<b>Wulfsberg Electronics</b> <i>A Chelton Group Company</i>	
<b>APPROVALS</b>			
DRAWN	R. Durall	4-4-05	<b>TITLE:</b> <b>SERVICE BULLETIN WSB IDU-III-15</b> <b>(SOFTWARE APPLICATION VERSION 5.0B)</b>
CHECKED	D. Boston	4-4-05	
PRODUCT MANAGER	---	---	
ENGINEER	R. Durall	4-4-05	<b>SIZE</b> 
ISSUED	R. Talken	4-7-05	<b>CAGE CODE</b> <b>1B7G3</b>
		<b>DWG NO.</b> <b>150-045151</b>	<b>REV</b> <b>C</b>
<b>Typed signatures indicate approval. Handwritten signature approval of this document is on file at Wulfsberg Electronics, Prescott, Arizona.</b>		<b>SCALE: NONE</b>	<b>DO NOT SCALE DRAWING</b>

## SERVICE BULLETIN

**EQUIPMENT:** IDU-III

**BULLETIN NUMBER:** WSB IDU-III-15 Revision C

**Figure 13 New EFIS to Sfim PA-85 Wiring Diagram**

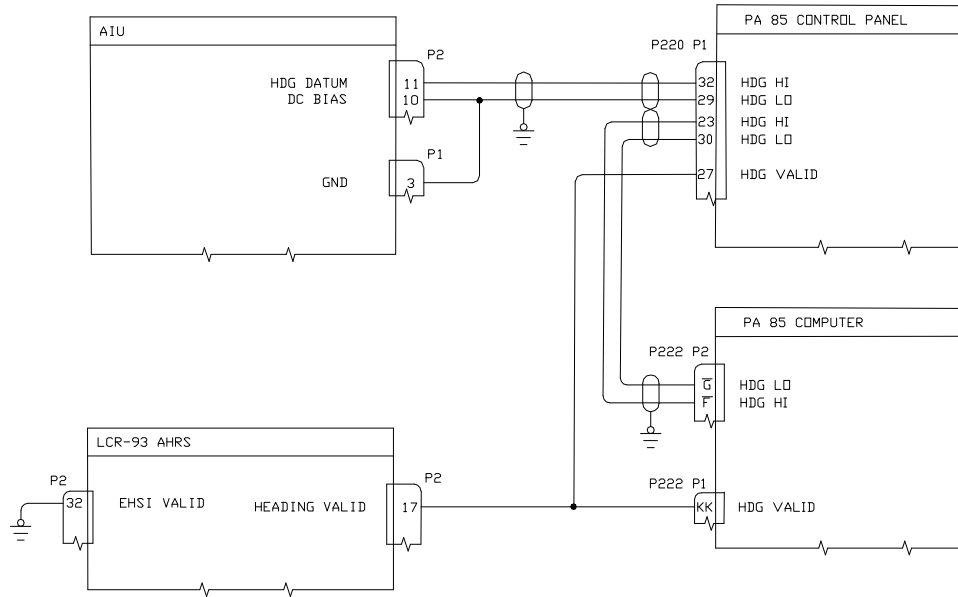
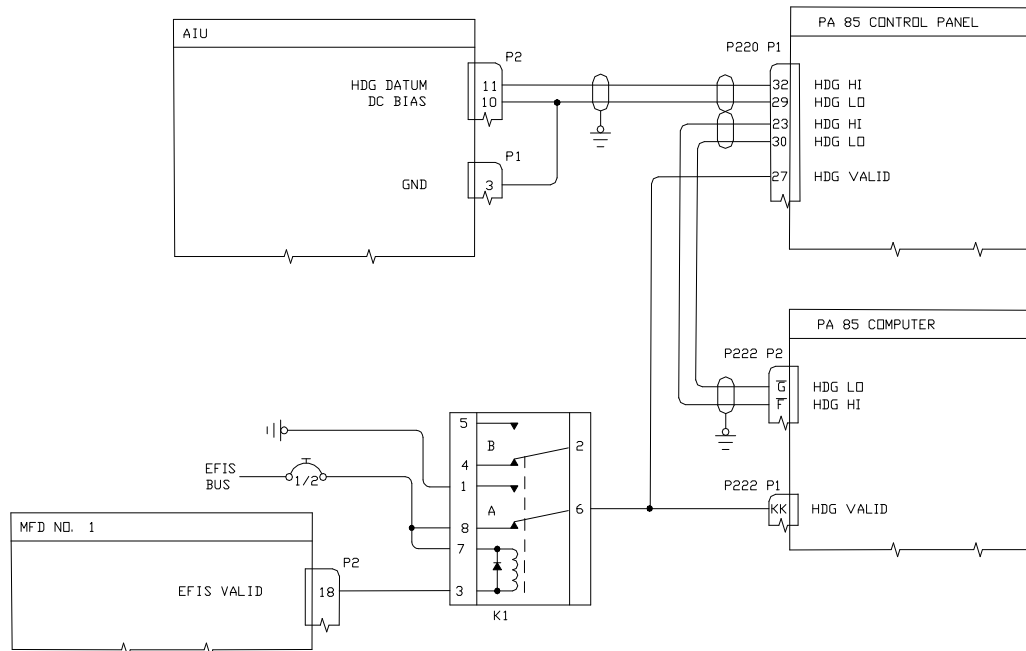
Rotorcraft with the EFIS interfaced to a Sfim PA-85 autopilot under Chelton STC SR02209AK or SR02230AK must modify the wiring as follows using Figures 12 and 13 below:

1. Locate and install a DPDT relay in the aircraft. The relay shall be mounted using material, hardware, and techniques as outlined in FAA AC 43.13-1B and 2A or later revision.
2. Disconnect the wire from P2-Pin 17 of the Litef LCR-93 AHRS.
3. Extend this wire and connect to the wiper of the relay installed in Step 1.
4. Install a new wire from the EFIS MFD P2-Pin 18 to the low side of the relay coil.
5. Use or install a circuit breaker on the EFIS bus labeled "EFIS SWITCHING".
6. Install a new wire from the circuit breaker to the high side of the relay coil and the Normally-Closed contact of the relay.
7. Install a new wire from the Normally-Open contact of the relay to airframe ground.

- Using the IDU Limits program, set the EFIS Autopilot Valid Polarity to "Open = EFIS Valid" (See EFIS Installation Manual, Doc. 150-045264 or 150-045057, Chapter 5 for further details on programming the IDU Limits).
